Core X Partners – Cold Storage Warehouse Facility
Main Street
Site Plan Review
M30 L1

Town of Gorham
Planning Board Meeting
November 6, 2023

ITEM 1 - Discussion – Site Plan - Core X Partners – a request to construct a cold storage warehouse building consisting of freezer warehouse space, office space, cold docks and battery charging and material handling equipment storage. Zoned I. Map 30, Lot 1. Represented by Chris Taylor, P.E. from Sebago Technics.

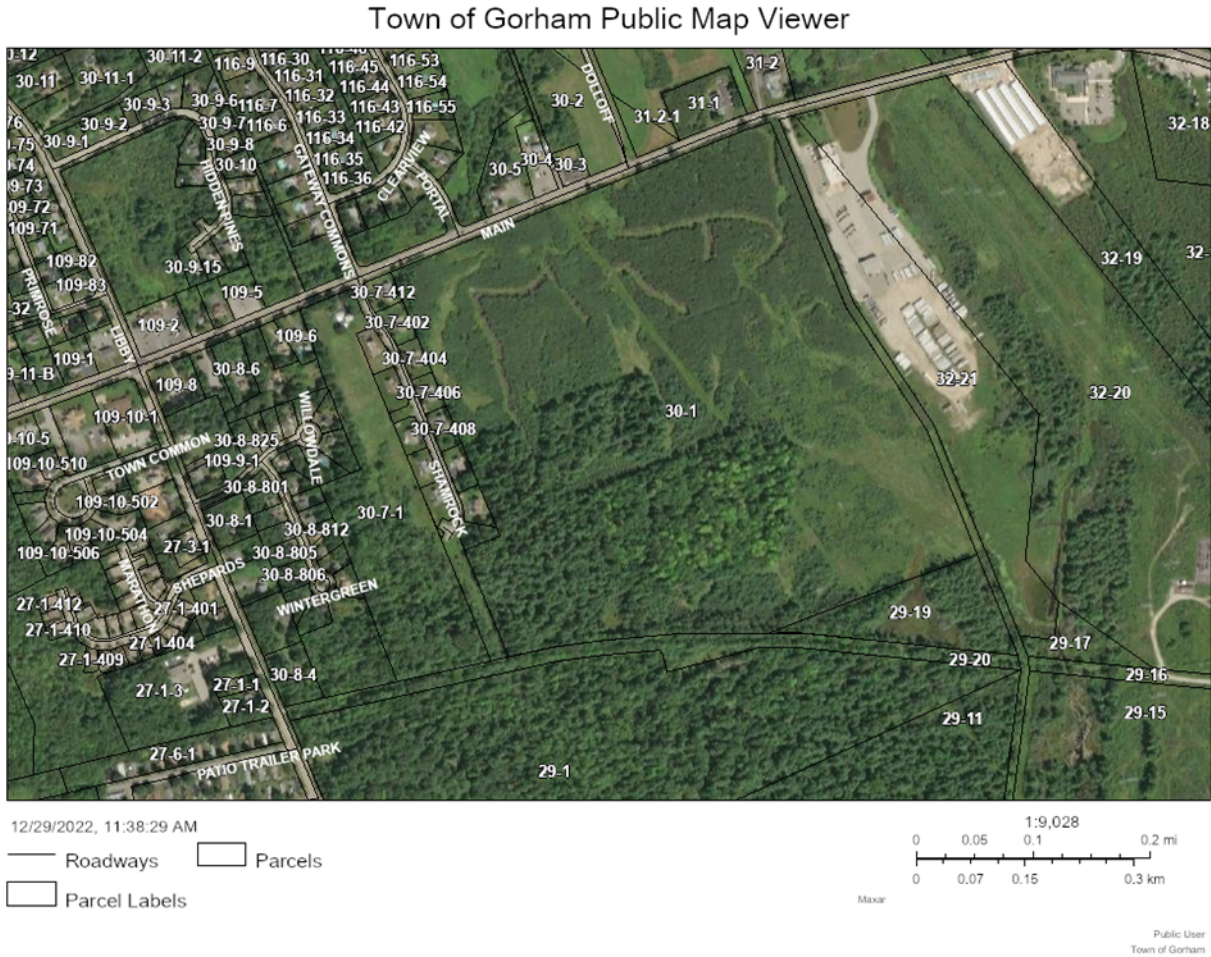
- The site contains wetland areas, as shown on the sketch plan map included with the application. These wetlands are also shown on the Town of Gorham’s GIS inventory as well as on the Beginning with Habitat map inventory provided by Maine Inland Forestry and Wildlife (IF&W), which also shows a significant vernal pool on the southern end of the site.
- A letter from IF&W staff dated March 3, 2023 indicated that no significant wildlife habitat would be directly affected by the project.
- A letter dated October 29, 2020 from Maine Natural Areas Program staff indicated that no known rare botanical features are located on the site.
- The application materials describe one “archeologically sensitive area” on the site. The applicant has stated they do not propose any disturbance of this area.
